MFN No. 012-94  
Docket STN 52-004

Subject: NRC Requests for Additional Information (RAIs) on the Simplified Boiling  
Water Reactor (SBWR) Design

RAI Purdue #1

# CHIMNEY/TOP GUIDE DETAILS

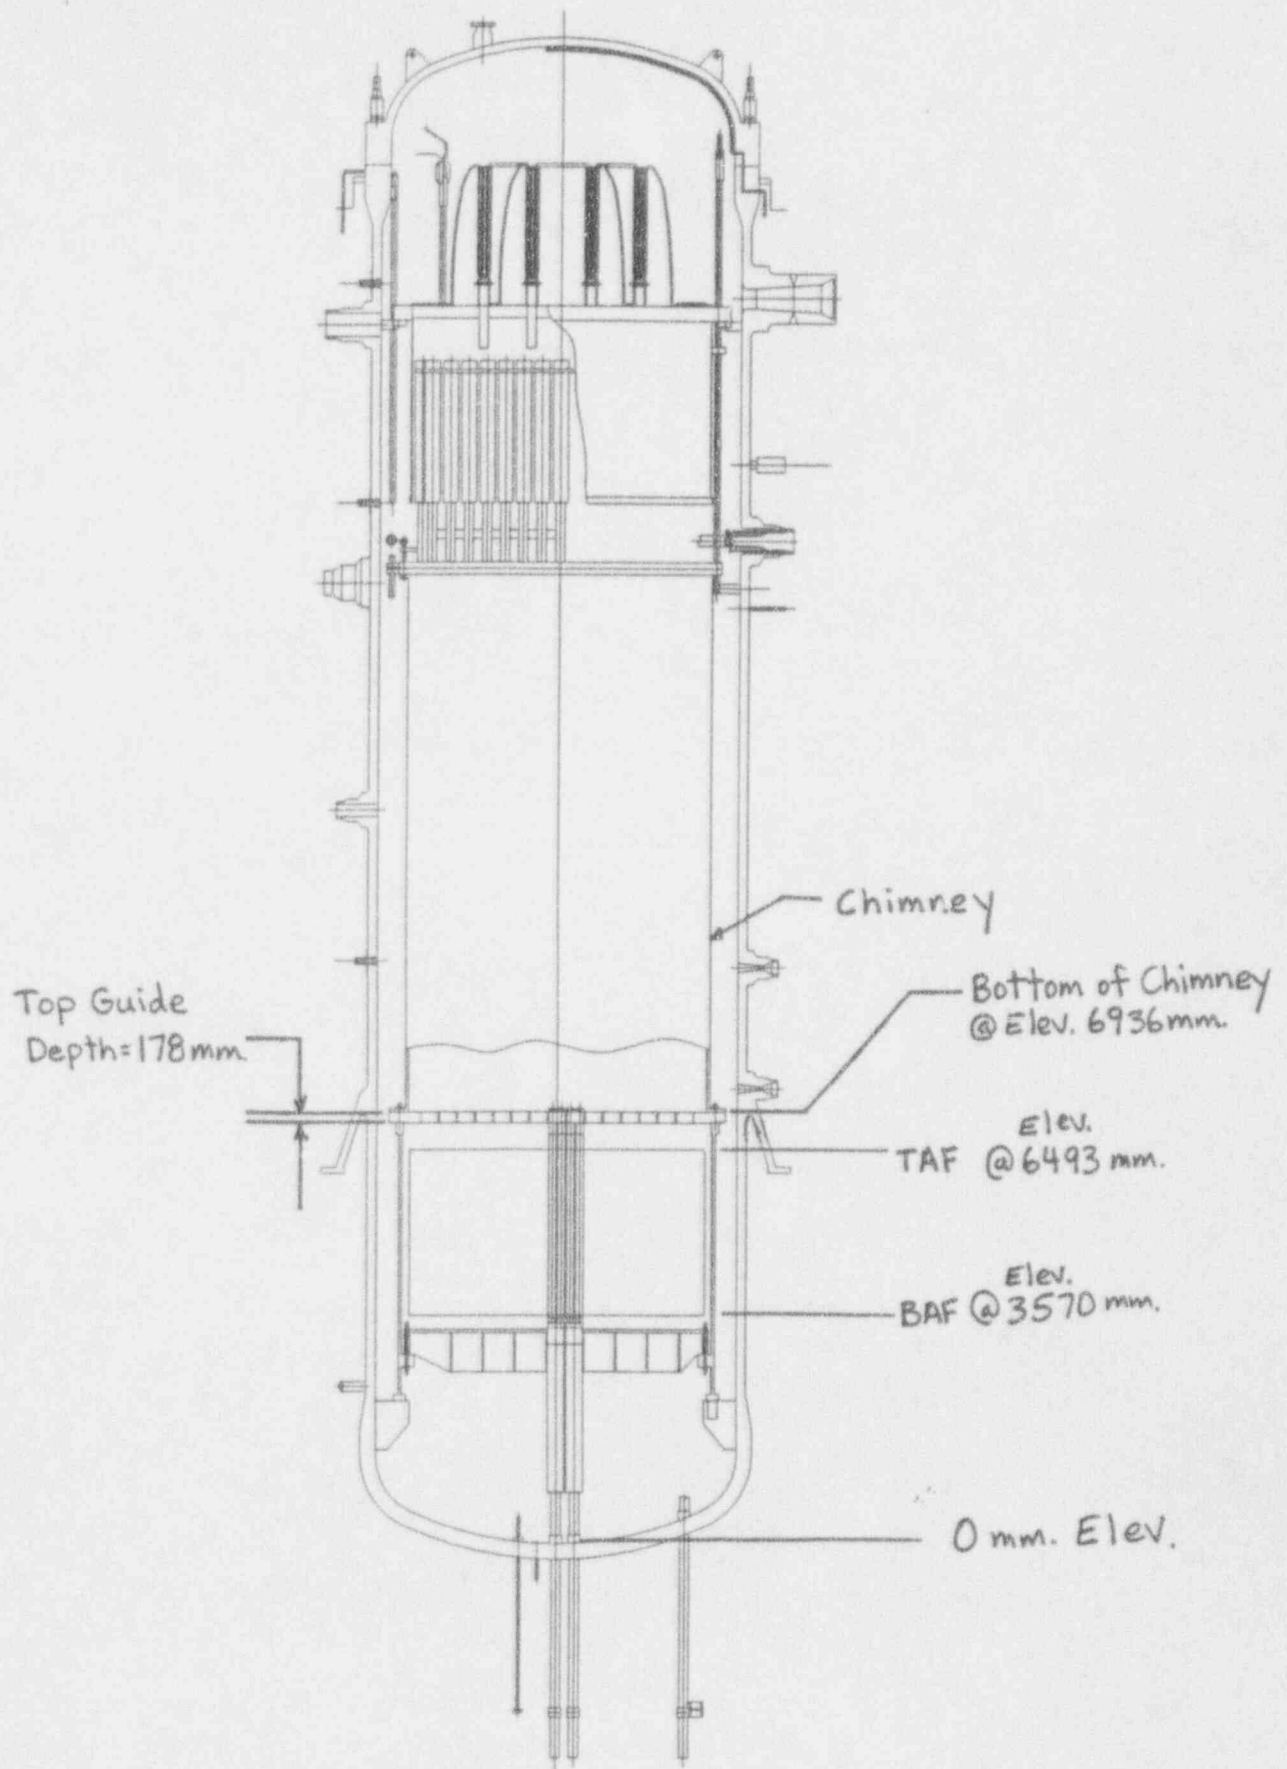
Please provide information on the gap size between the top of the core and bottom of the chimney sections.

The chimney and partitions are supported by the top guide. The gap between the top of the active fuel (TAF) and the bottom of the chimney sections is 443 mm. The gap between the TAF and the bottom of the Top Guide is 265 mm. (See the attached sketch, which shows the Chimney/Top Guide details.)

FIGURE 1

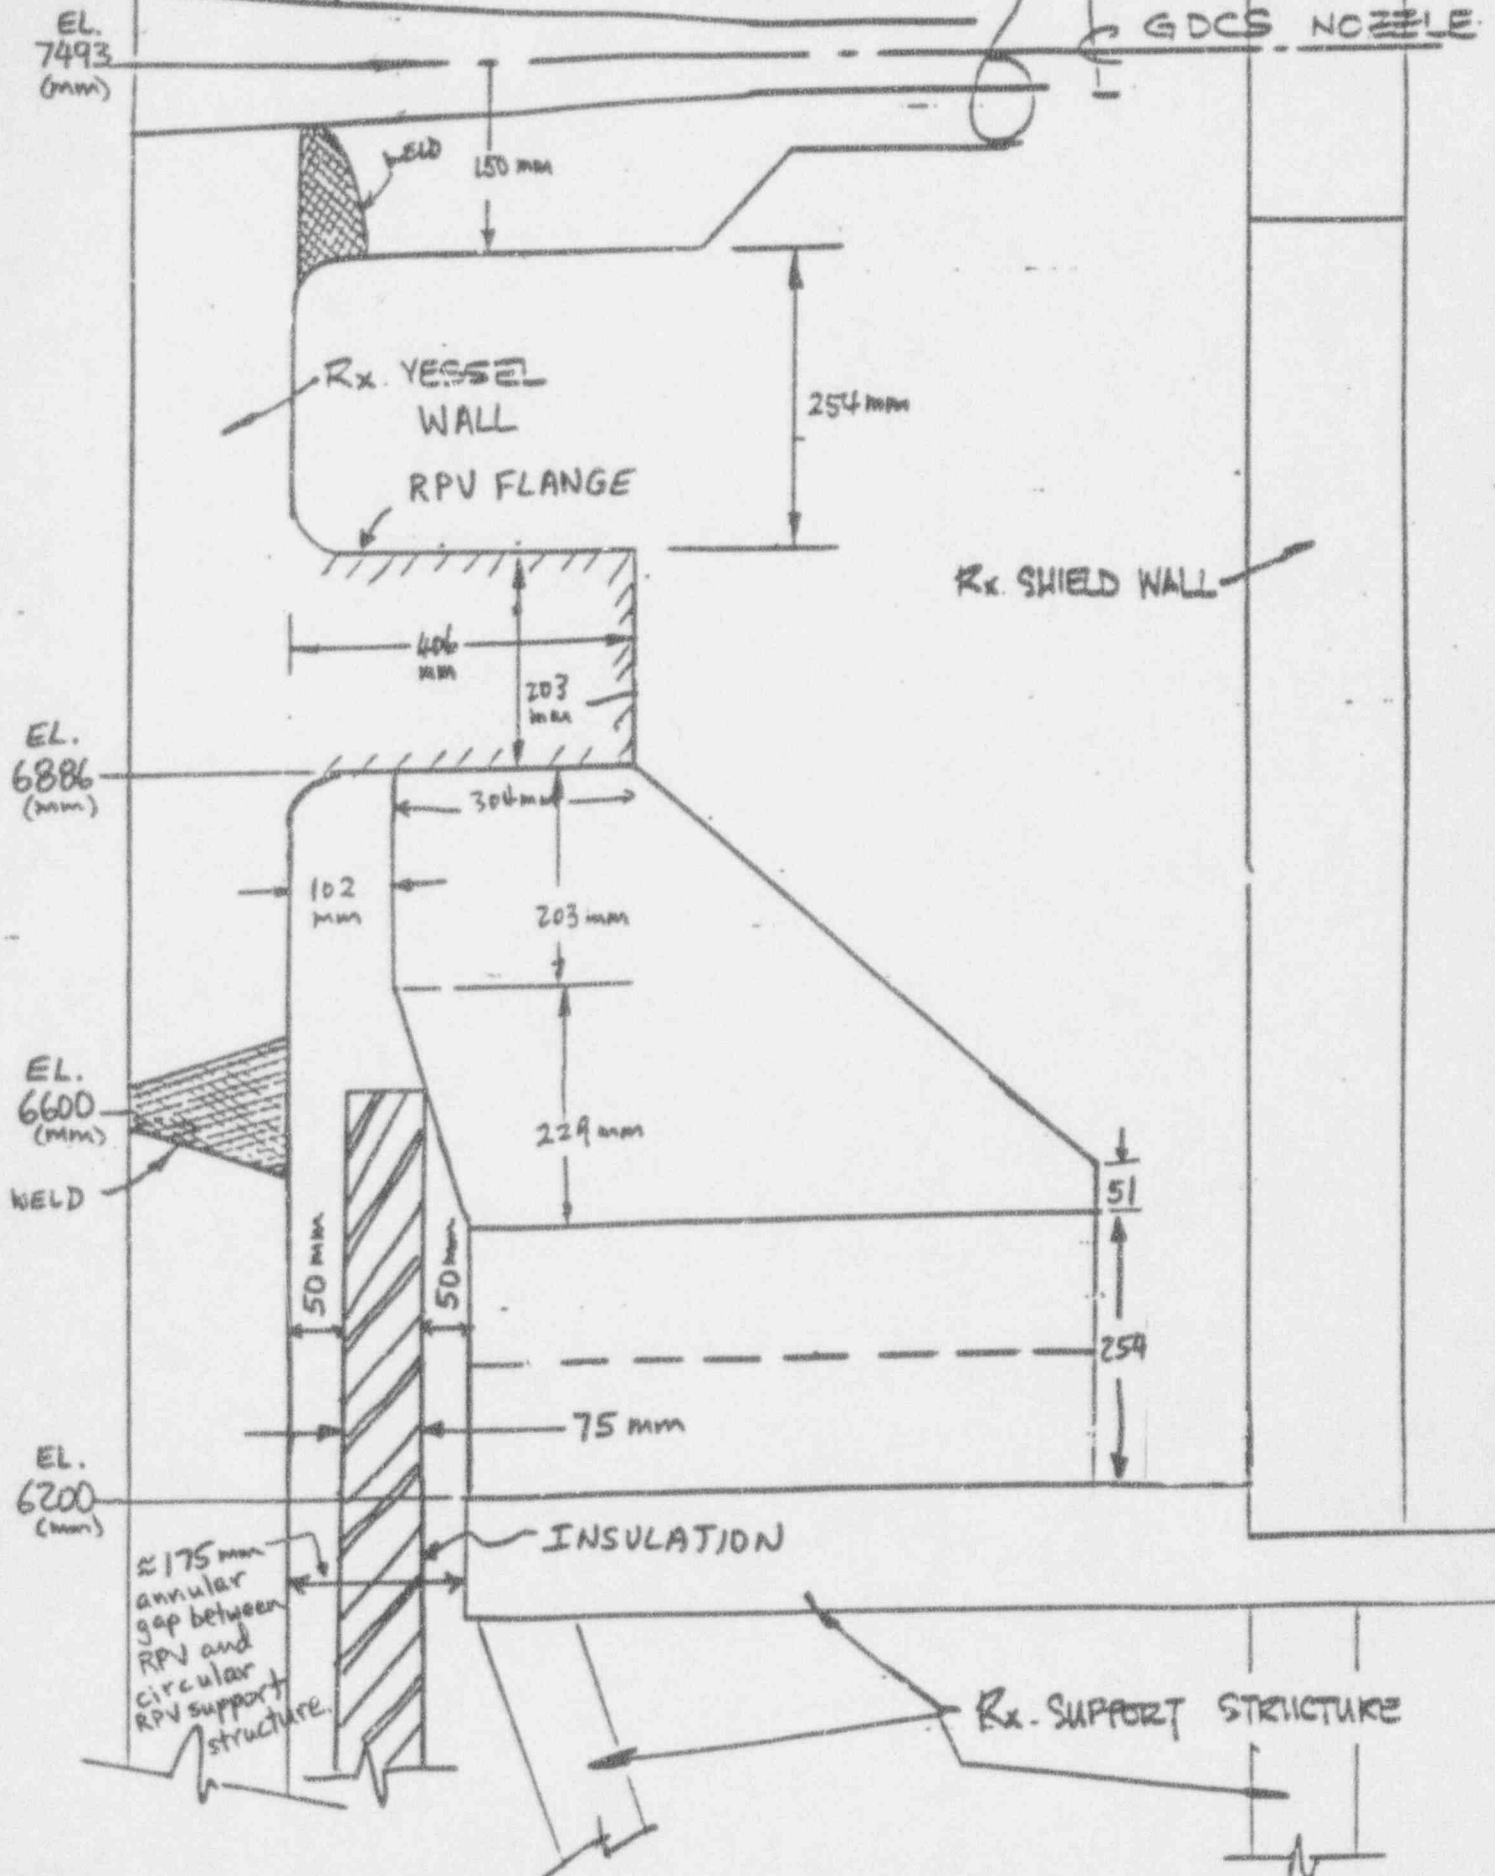
Detailed information on the opening area at RPV skirt connecting the upper and lower drywell is needed.

The RPV skirt type support design is in the process of being changed to a sliding type support design. This change is being made in order to minimize the adverse effects of high neutron fluence at the RPV skirt. Upon GE Technical Integration group approval of this design change, the RPV detail drawings will be revised to show the sliding type support details. Preliminary detailed information on the sliding support configuration and the insulation arrangement at the RPV support are provided in the attached Figures 1 through 4.
